Draft Environmental Impact Report

the Grove
Mixed-Use Development
Shrewsbury, Massachusetts
EEA #15138

**Re: Draft Environmental Impact Report (EEA #15138)
the Grove Mixed-Use Development, Shrewsbury**

Figure 9. Chelmsford Building Proposed Conditions

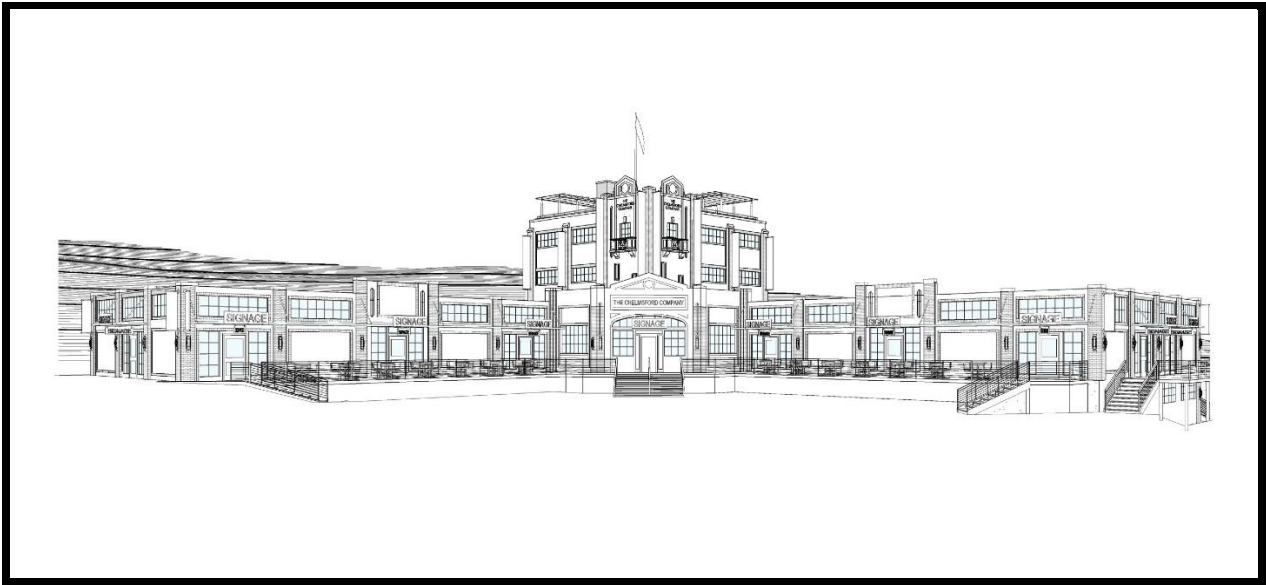
1-7	[T]he Proponent should provide elevation drawings of the proposed rehabilitation of the Chelmsford Ginger Ale Company building and the design of the proposed Phase 1 construction for consideration during the MHC consultation process.	Figure 9 shows the proposed elevation of the rehabilitated Chelmsford Building. All construction will take place as part of the Project build-out—no separate Phase I now is proposed on the main part of the site.
1-8	I strongly encourage the Proponent to incorporate a robust program of construction waste recycling and solid waste management given the proposed building and parking lot demolition associated with the project.	The Project will comply with all applicable Federal, State, and local requirements regarding the handling, recycling, and disposal of solid waste generated by the Project. To the extent feasible, demolition materials will be segregated on-site for reuse and disposal.

Figure 28. Proposed Transit, Pedestrian, and Bicycle Access

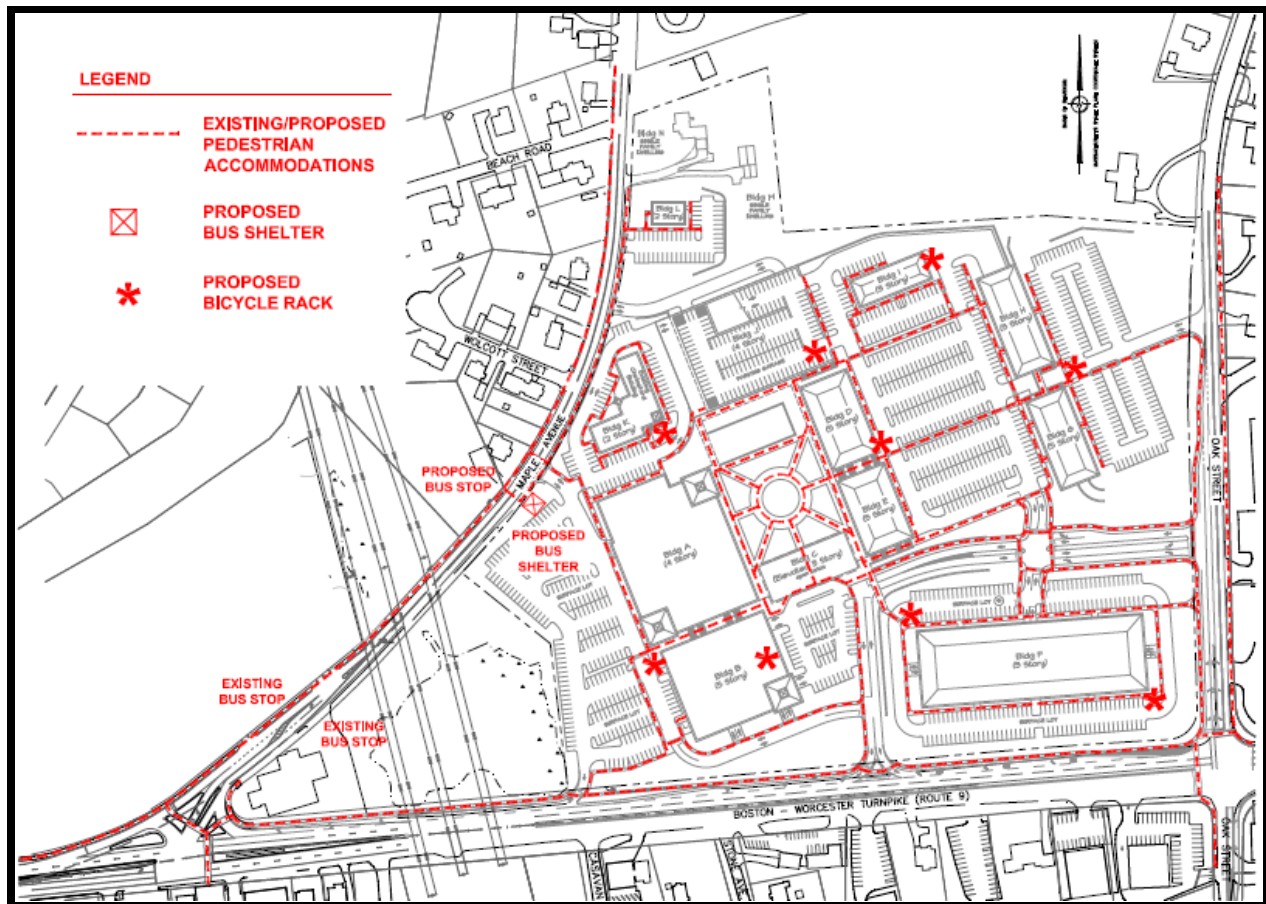
Code	Comment	Response
6-5	Consider... bicycle racks for users of the project.	Bicycle racks are proposed throughout the site. Refer to Figure 28.
6-6	[C]onsideration... continuing the Route 9 roadway improvements and aesthetics north and east on Maple Avenue and Route 9 to the edge of the project limits including sidewalks and decorative light poles.	Aesthetic improvements along Maple Avenue are not currently proposed as part of this project. Mid-block crosswalks are proposed to connect with the Project site's internal sidewalks and the existing sidewalk on the northwest side of Maple Avenue.
6-7	[Demonstrate a]dequate locations for refuse disposal and snow storage.	As design development continues, the Proponent will identify the required refuse disposal and snow storage areas and incorporate them into the Site Plan submitted to the Town.
6-8	The applicant shall consult with the Engineering Department about the existing water and sewer mains in Maple Avenue and Route 9.	The applicant has met with Town officials several times to discuss water and sewer services and will continue to work with the Town during the local approval process.

Figure 30. Conceptual Mitigation Plan Oak Street at Route 9*

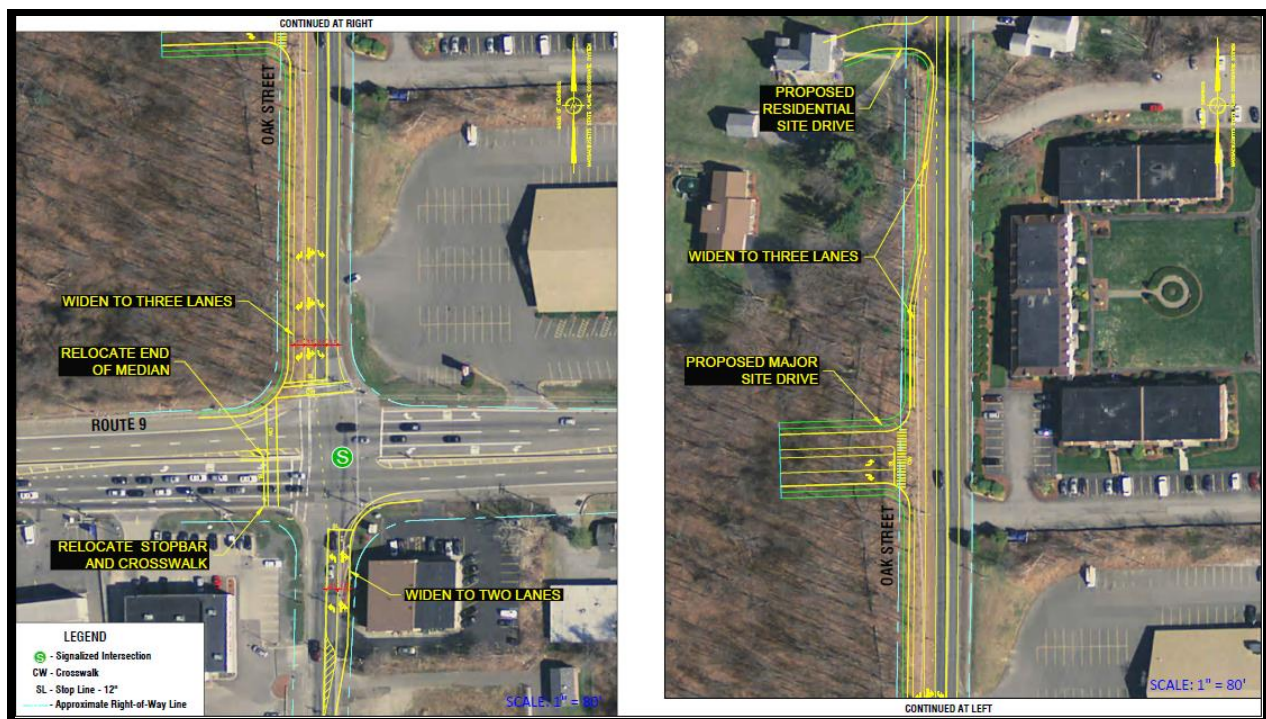
1-15	These conceptual plans should include not only on-site work, but any proposed off-site work associated with transportation improvements.	Conceptual plans have been developed for each off-site location where roadway/intersection geometry changes are proposed. These improvements are shown in Figure 29, Figure 30, and Figure 31 in the Draft EIR.

2-16	The DEIR should include sufficiently detailed conceptual plans (preferably 80-scale) for proposed roadway improvements in order to verify the feasibility of constructing improvements. These plans should clearly show proposed lane widths and offsets, layout lines and jurisdictions, and land uses (including access drives) adjacent to areas where improvements are proposed.	Conceptual plans have been developed for each off-site location where roadway/intersection geometry changes are proposed. These improvements are shown in Figure 29, Figure 30 and Figure 31.
2-17 and 2A-17	Any proposed mitigation within the state highway layout and all internal site circulation must be consistent with a Complete Streets design approach that provides adequate and safe accommodation for all	All of the proposed geometric improvements are consistent with the Complete Streets design approach. The proposed improvements are shown in Figure 29, Figure 30 and Figure 31.
